CITY of NOVI CITY COUNCIL

Agenda Item 6
January 28, 2013

SUBJECT: Consideration of a request from Darren Yanke for a variance from Section 11-278(a) of the Design and Construction Standards, which requires pedestrian safety paths to be constructed of concrete, to allow the use of brick pavers for a sidewalk within the public right-of-way. (The subject property occupies parcel number 22-35-280-001 and is located at 41621 Hampshire Street).

METHOD OF CONSTRUCTION

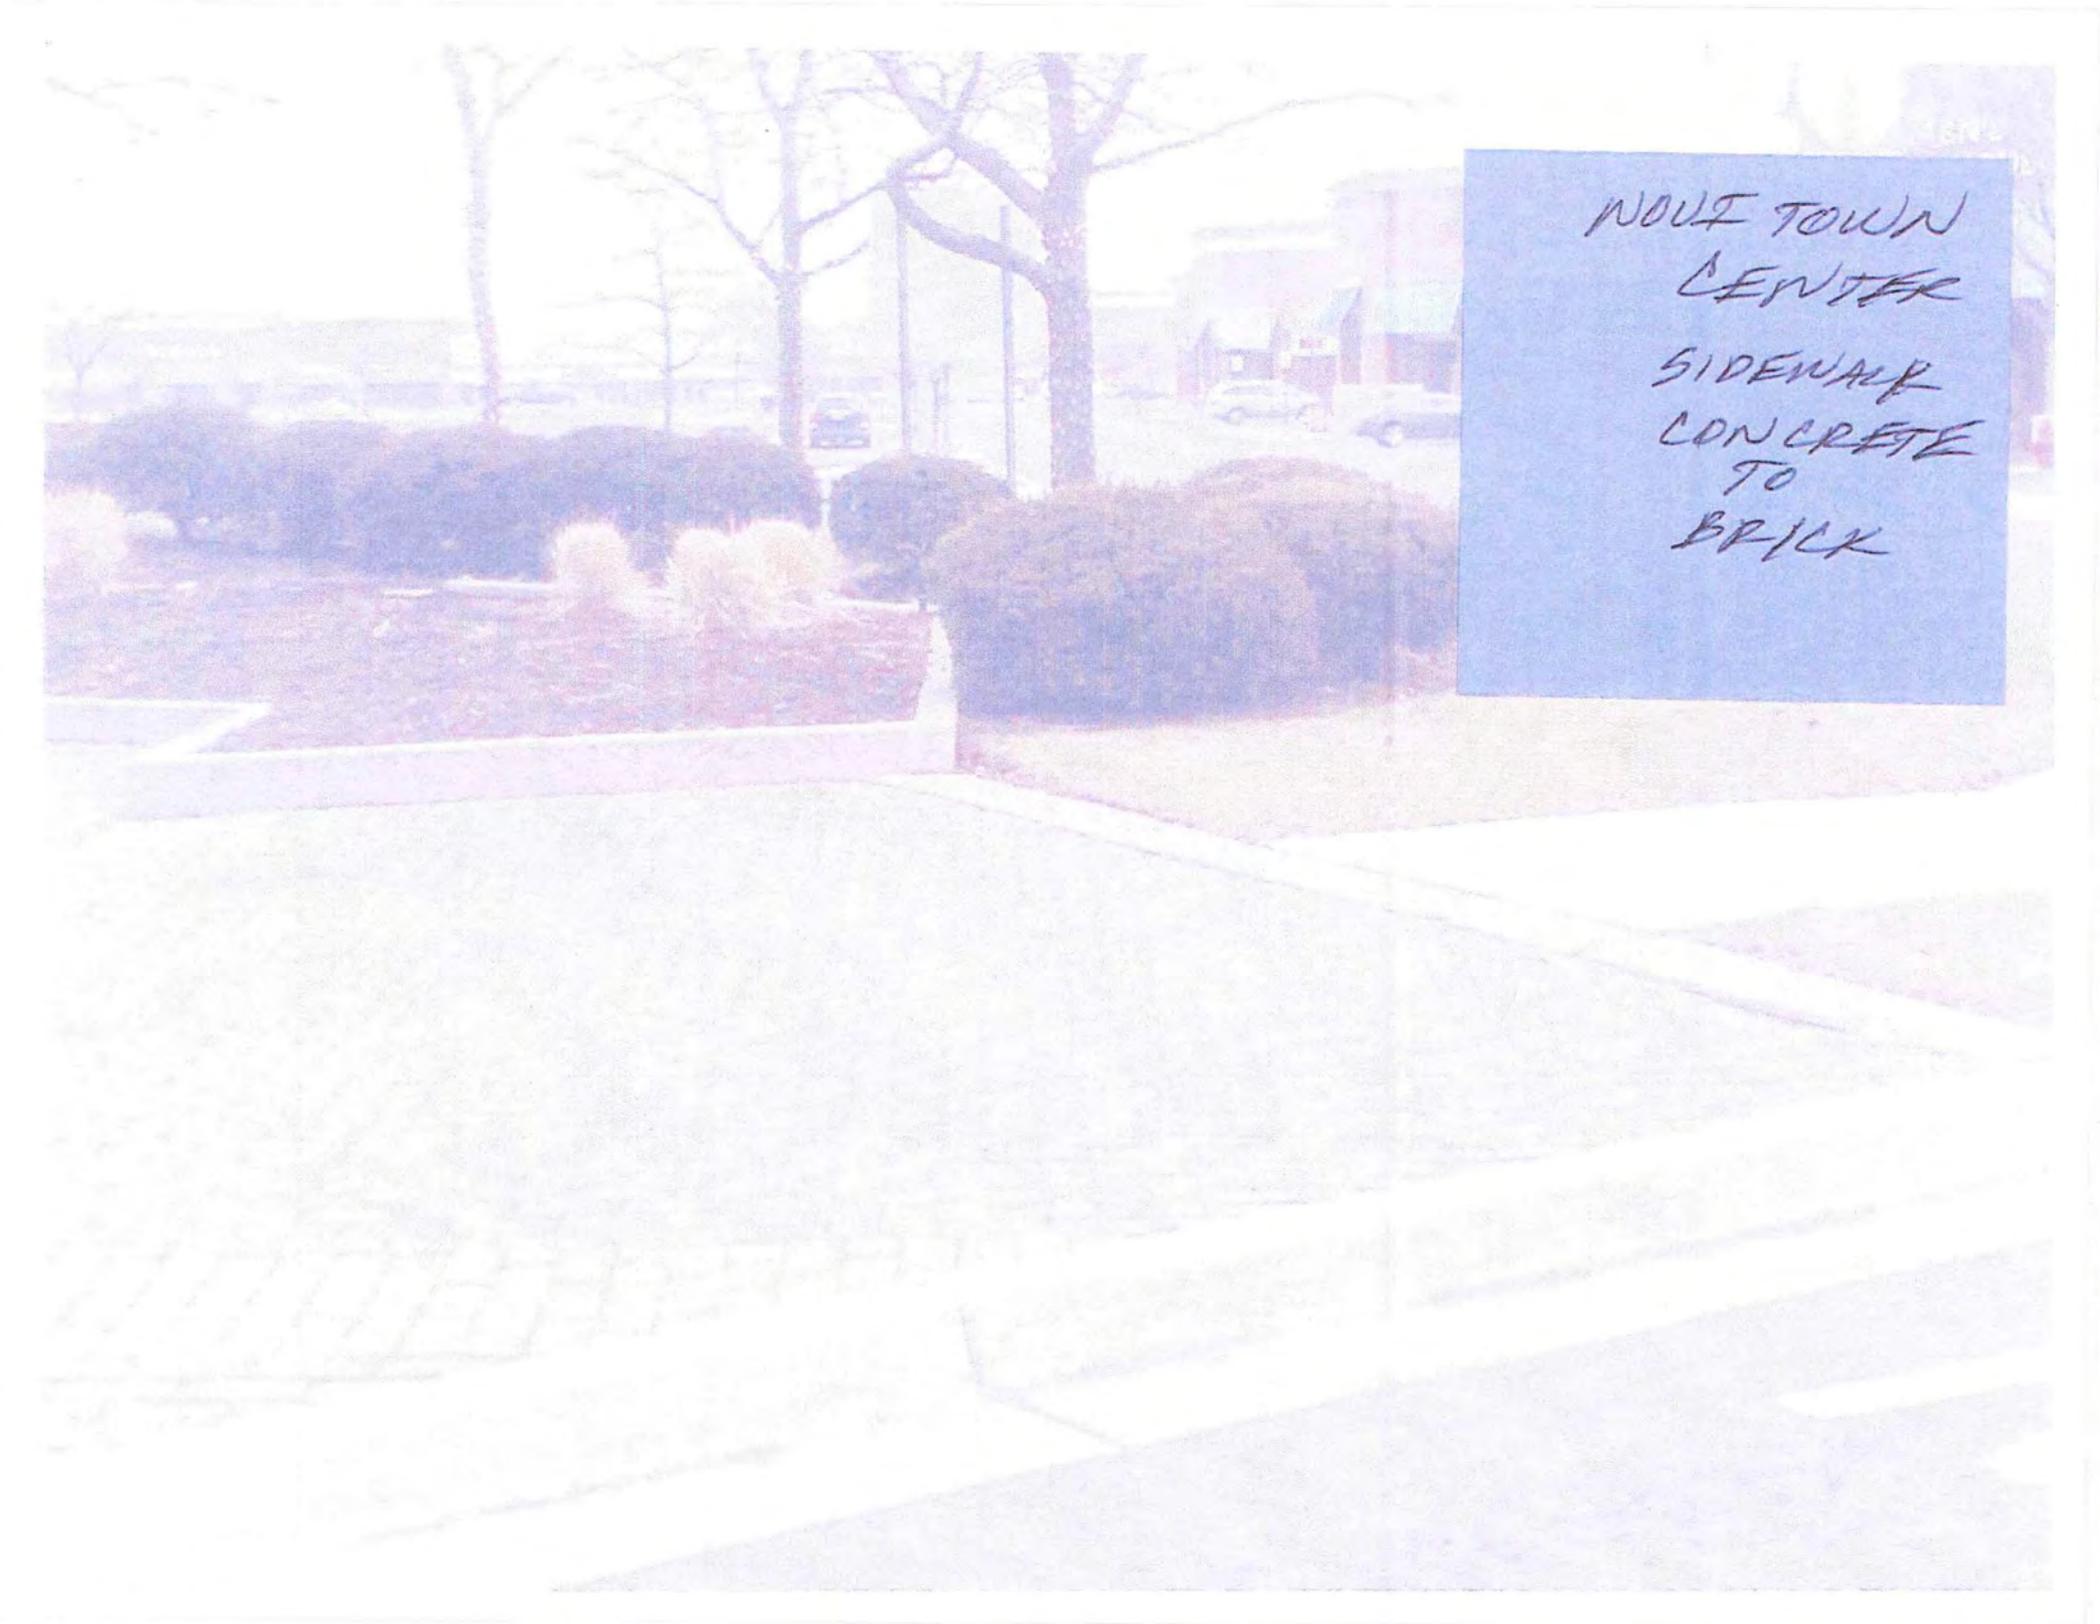
The applicant has filed a Design and Construction Standards Variance Request for the use of brick pavers as a paving material for a public pedestrian safety path within the Right-of-Way. The Variance Request proposed an 18-inch composite cross-section consisting of brick pavers placed on $\frac{3}{4}$ inches of sand on top of 5 inches of 21AA Crushed Stone and 10 inches of 1" x 3" crushed concrete with geotextile fabric in between the each base layer. The Design and Construction Standards (DCS) Section 11-278(a) that Pedestrian safety paths shall be constructed in concrete. The applicant has requested the variance in response to a ROW violation issued on October 8, 2012 for work completed within the ROW without a permit. Part of the work completed was a brick paver driveway that removed the existing concrete pedestrian safety path.

The use of Portland Cement Concrete as a construction material for pedestrian safety paths functions to minimize both the locations where a change in level occurs and effort required to correct changes in level that fall out of compliance. The use of brick pavers as a construction material for a public pedestrian safety path is in direct contrast with the Americans with Disabilities Act Compliance Transition Plan for public sidewalks and pathways. Brick pavers deviate substantially from the performance of required DCS cross-section. The proposed material provides significantly more points where a vertical obstacle may occur over time. Requiring the applicant to maintain the brick pavers through a license agreement is difficult to enforce, consuming City resources that could otherwise be allocated to bring existing ADA deficiencies into compliance. In addition, the applicant has not demonstrated how complying with the DCS would result in a substantial hardship. For these reasons, the Engineering Division is recommending denial of the request for variance from the Design and Construction Standards.

RECOMMENDED ACTION: Denial of a request from Darren Yanke for a variance from Section 11-278(a) of the Design and Construction Standards, which requires pedestrian safety paths to be constructed of concrete, to allow the use of brick pavers for a sidewalk within the public right-of-way for the following reasons:

1. The performance of brick pavers as an alternative to concrete substantially deviates from the performance that would be obtained by strict enforcement of the standards related to heaving and settling of the sidewalk, compliance with the Americans with Disabilities Act Compliance and Transition Plan, and required long-term maintenance,
2. The use of brick pavers could be detrimental to public safety should heaving and settling occur that would create potential trip hazards,
3. The requirement for sidewalks to be constructed of concrete will not result in an exceptional, practical difficulty to the applicant as it has been applied uniformly throughout the City.
